SECTION 00 91 01

ADDENDUM NO. 1

BUILDINGS 5 & 6 RENOVATIONS
 San Mateo County Community College District

CAÑADA COLLEGE
 4200 Farm Hill Boulevard
 Redwood City, CA 94061

FINISH, WINDOW SCHEDULES

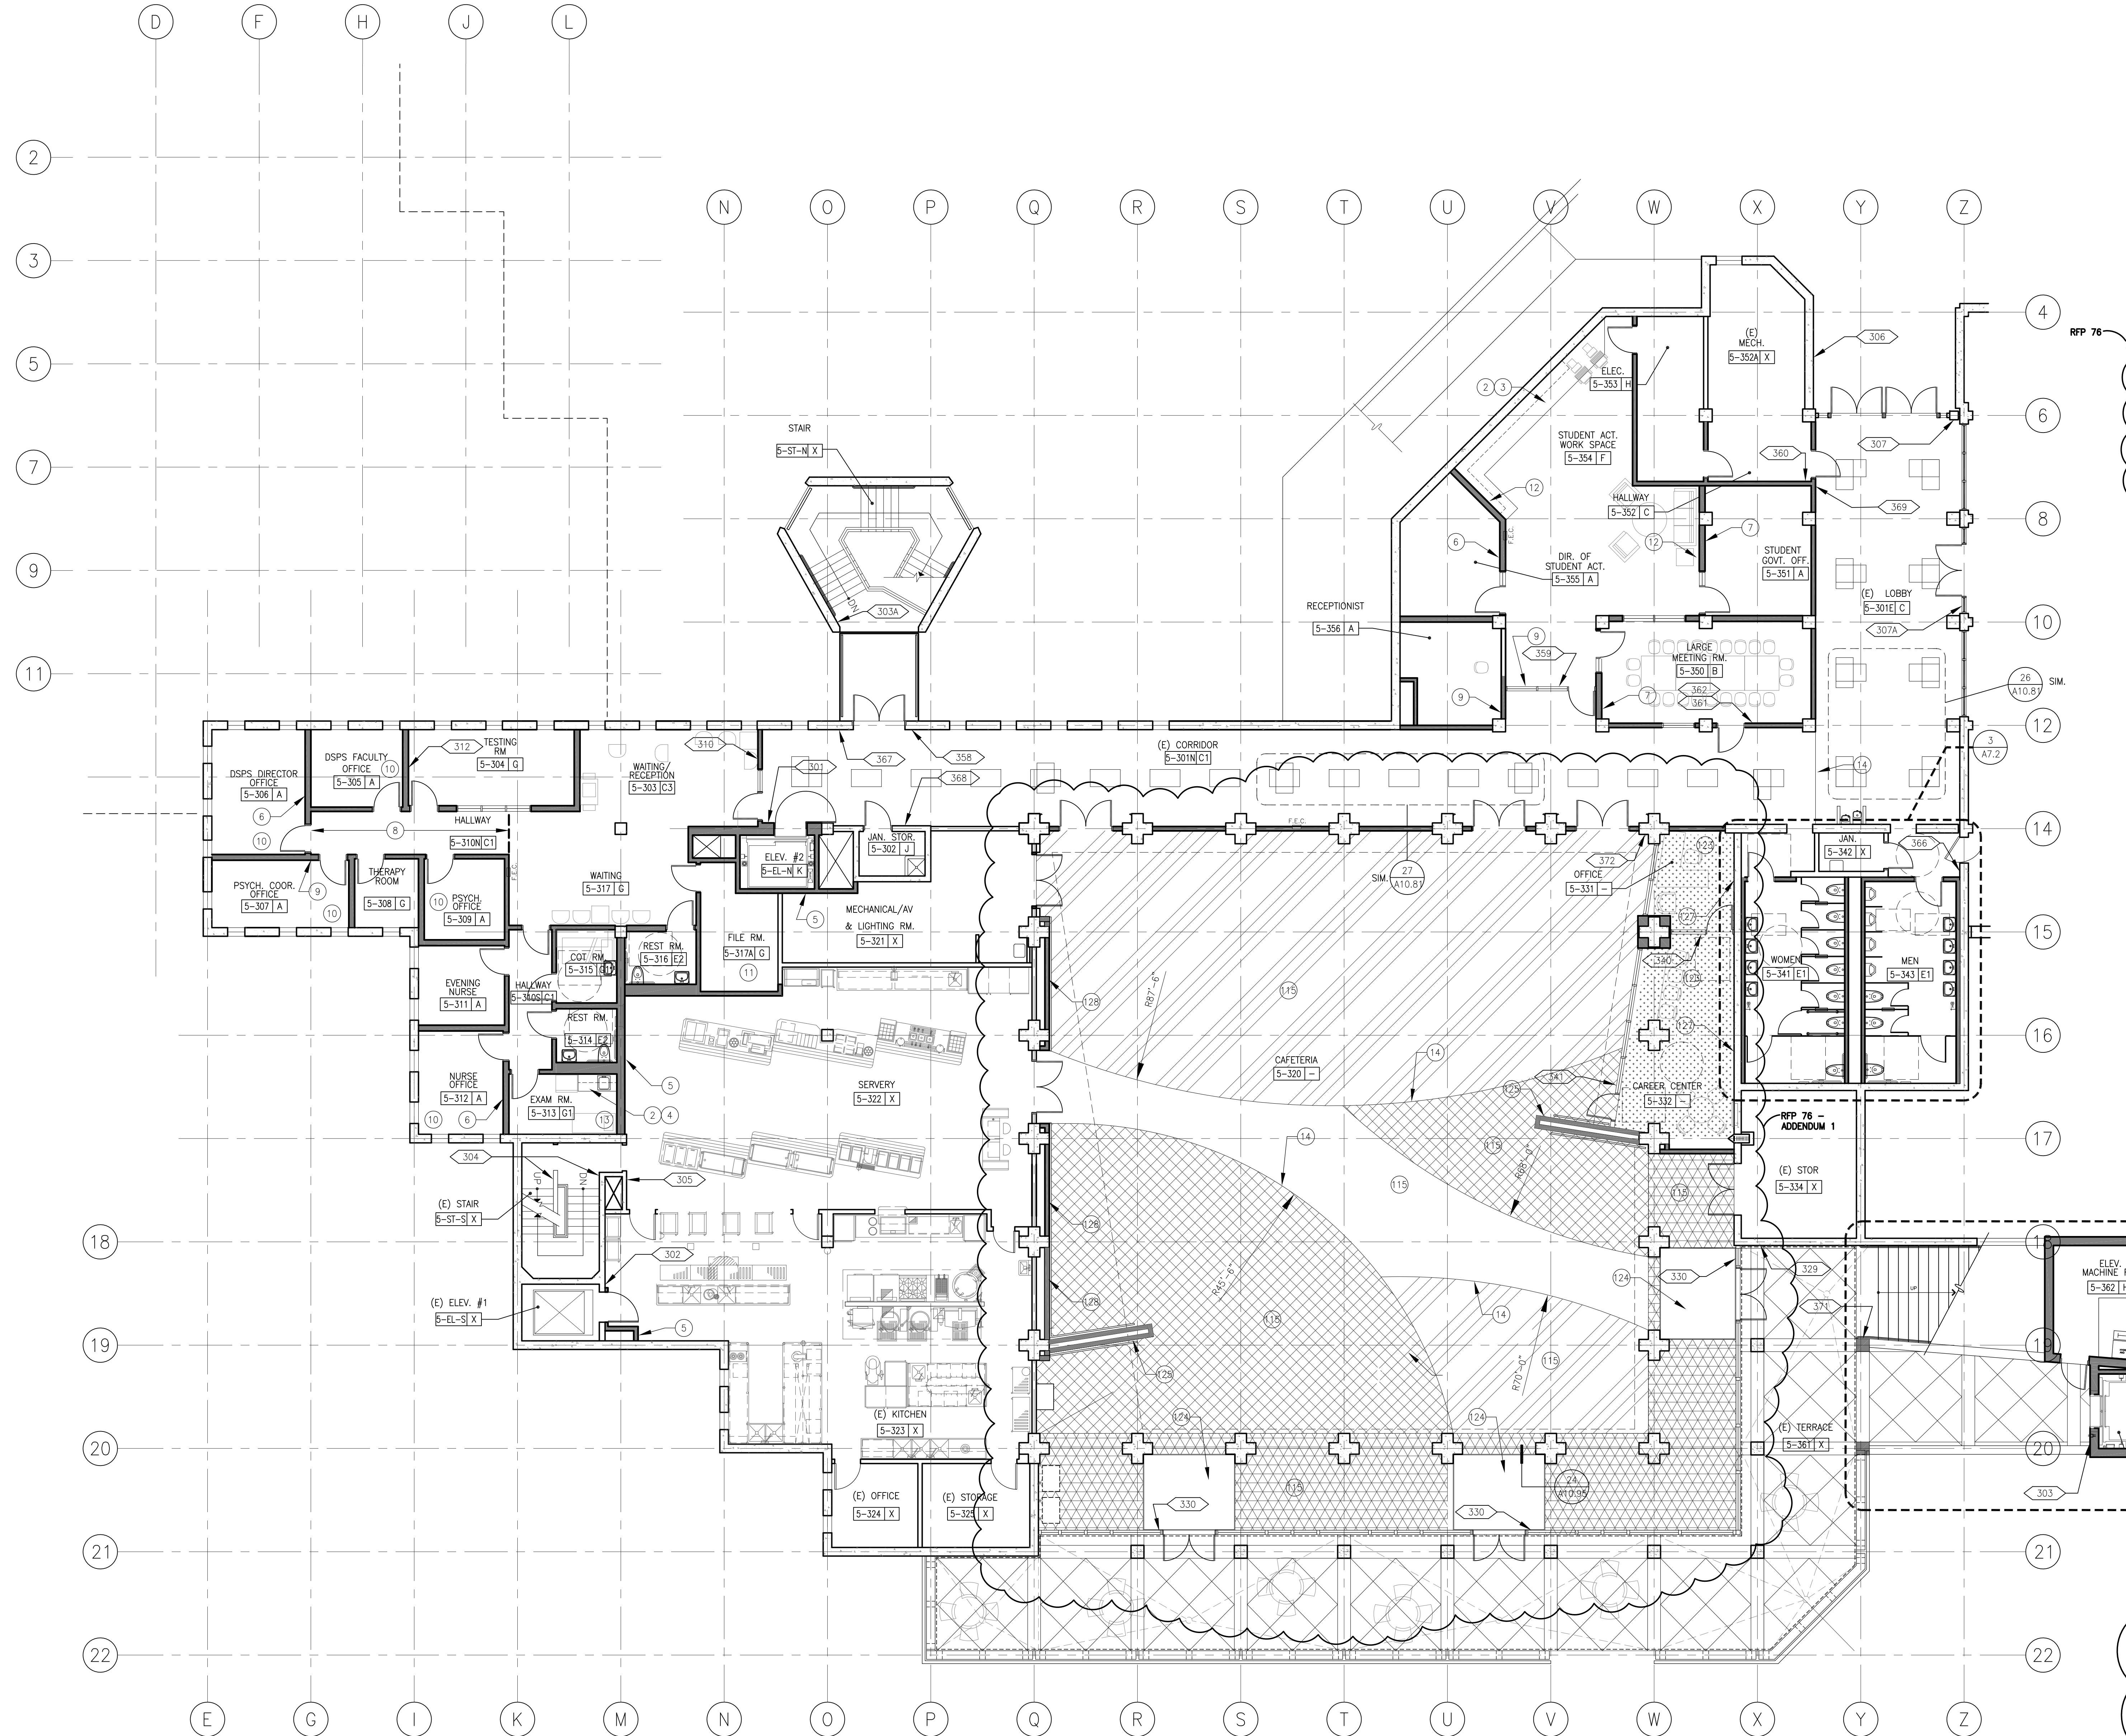
- A. Modified drawing as shown on attached revised Drawing A9.1R:
 - 1. Revised Finish Legend to include the following colors of Altro Dolce resilient flooring:

FLOOR	
RESILIENT FLOORING 5:	COLOR: ALTRO DOLCE # AD514.
RESILIENT FLOORING 6:	COLOR: ALTRO DOLCE # AD504.
RESILIENT FLOORING 7:	COLOR: ALTRO DOLCE # AD512.
RESILIENT FLOORING 8:	COLOR: ALTRO DOLCE # AD515.

Drawing Number: **A9.43R**

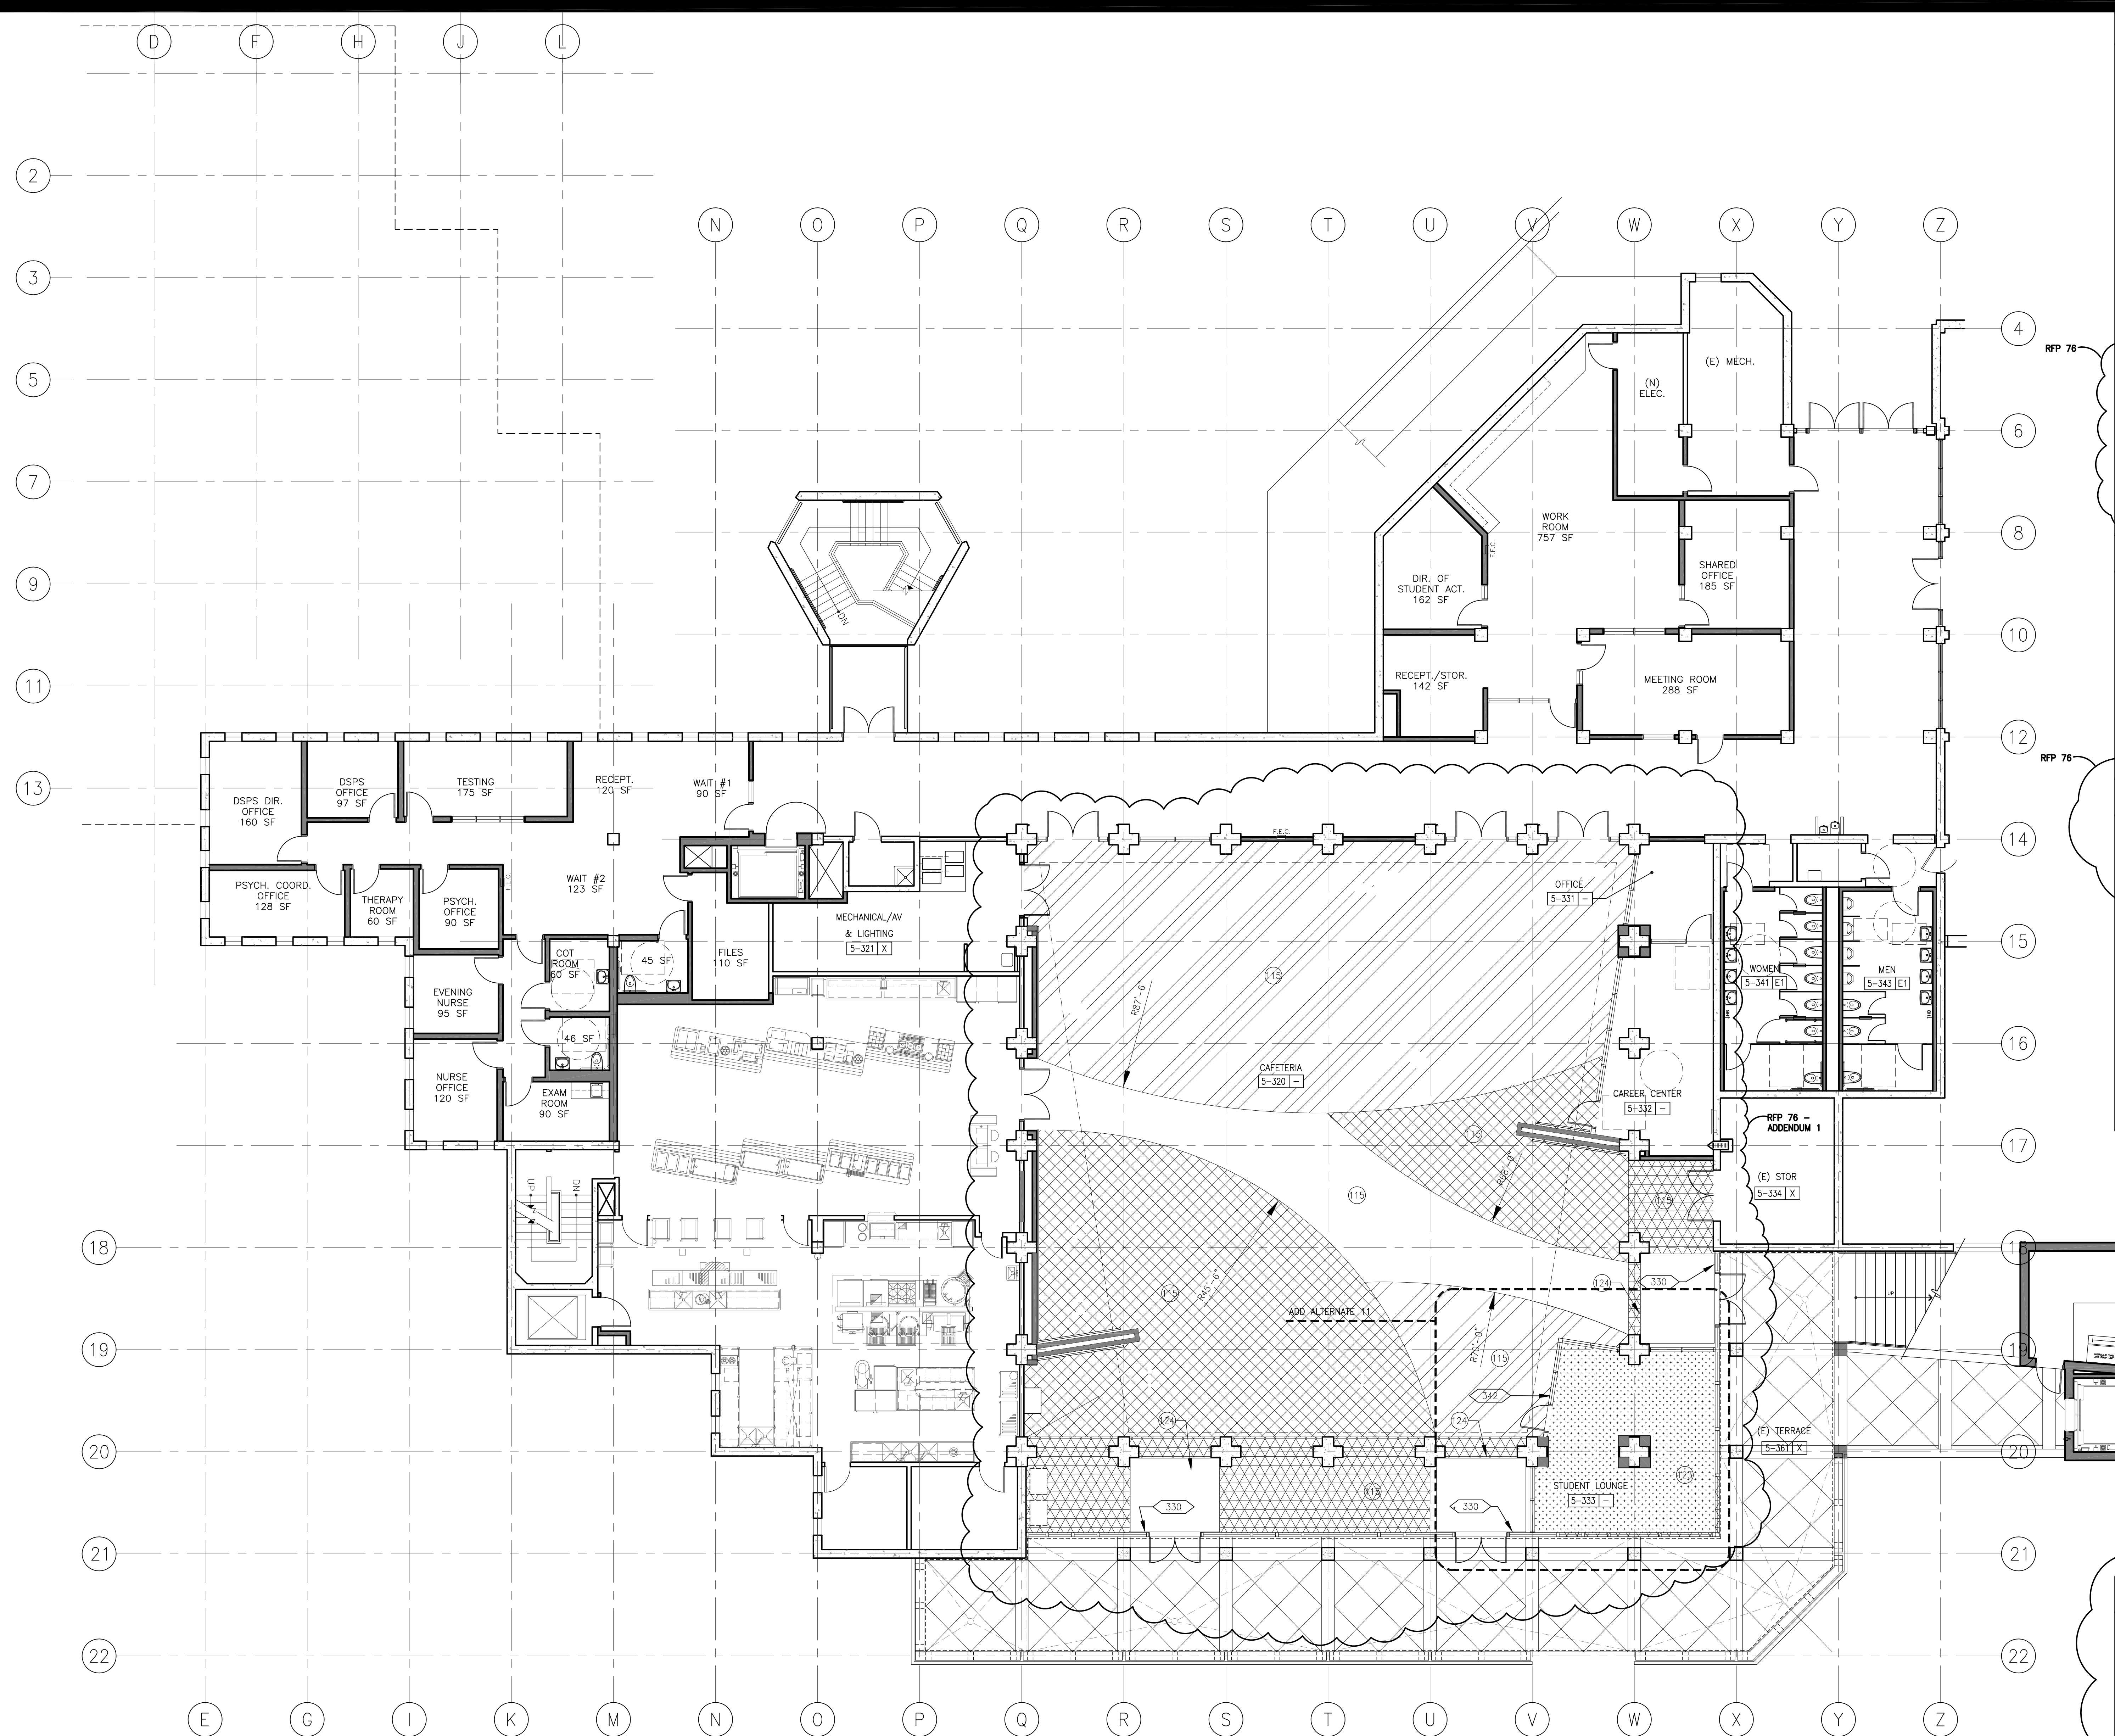
7. Drawing A9.43R – Third Floor Finish and Signage Plan.
 - A. Modified drawing as shown on attached revised Drawing A9.43R:
 1. Revised Finish Legend and Third Floor Finish and Signage Plan.

2. Revised Sheet Note 115.
8. Drawing A9.44R – Third Floor Finish and Signage Plan – Add Alternates.
 - A. Modified drawing as shown on attached revised Drawing A9.44R:
